INDESIT company

Model type:
HO87EF(IX)

Commercial code:
F026514

Notices

n1015019: Connection Connector Kits for New Ovens - Old Cook tops and Old Ovens - New Cook tops.

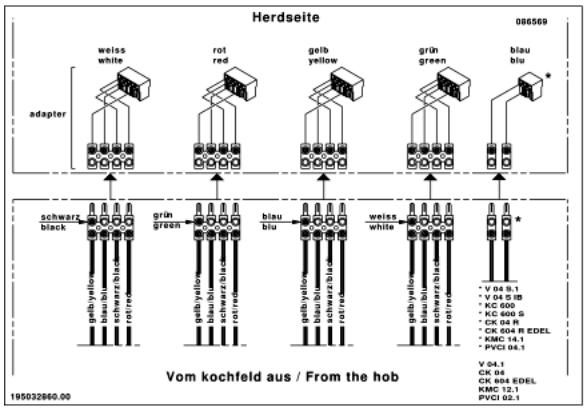
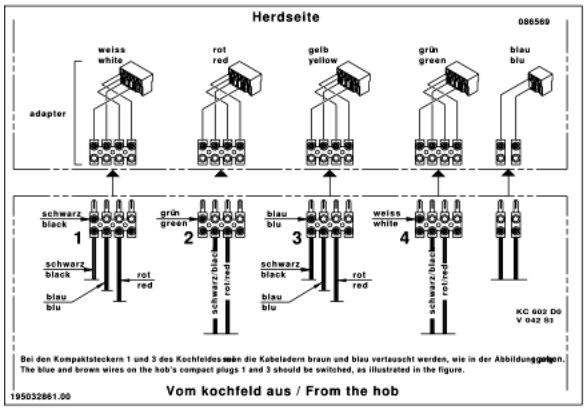
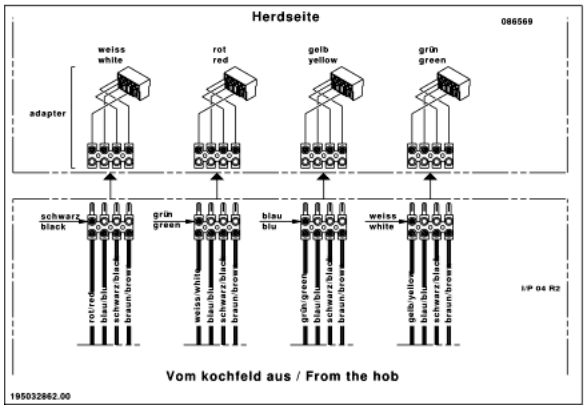
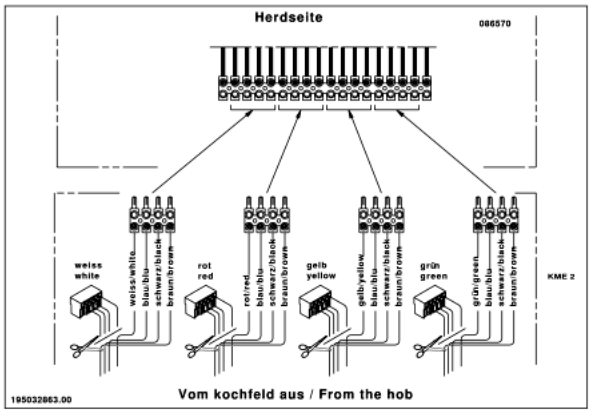
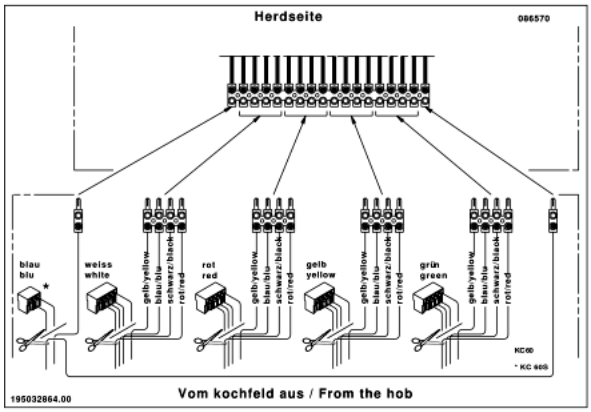
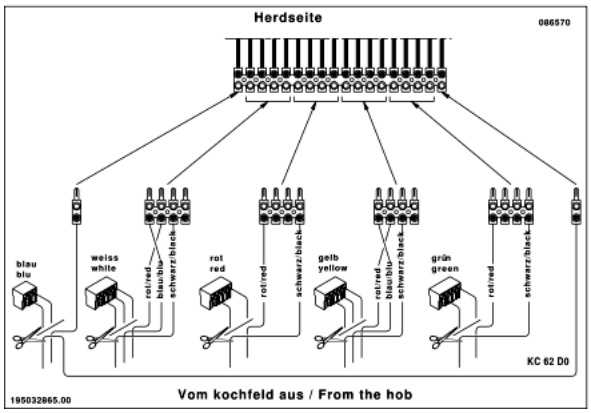
Connection Kits have been realized to assist in connecting the new ovens to the old cook tops and new cook tops to the old ovens.

Code SAT 086569 - Connection Kit for old cook tops and new ovens;
Code SAT 086570 - Connection Kit for new cook tops and old ovens;

The Kit code SAT 086569 is also equipped with 3 specific diagrams that highlight the connections to be performed, and the same for the Kit 086570.

Where the Kit 086569 is used you will need to check the match code on the diagram to the cook top model.
The same procedure is to be performed for the kit 086570.

In order to simplify the matching of the kit, we have realized in the enclosed diagrams to this Notice the following four diagrams:

1) Table A referred to the code SAT 086569 for all models of New Ovens - Old Cook tops.
2) Table B referred to the code SAT 086570 for all models of Old Ovens - New Cook tops.
3) Connections diagram kit code SAT 086569;
4) Connections diagram kit code SAT 086570.
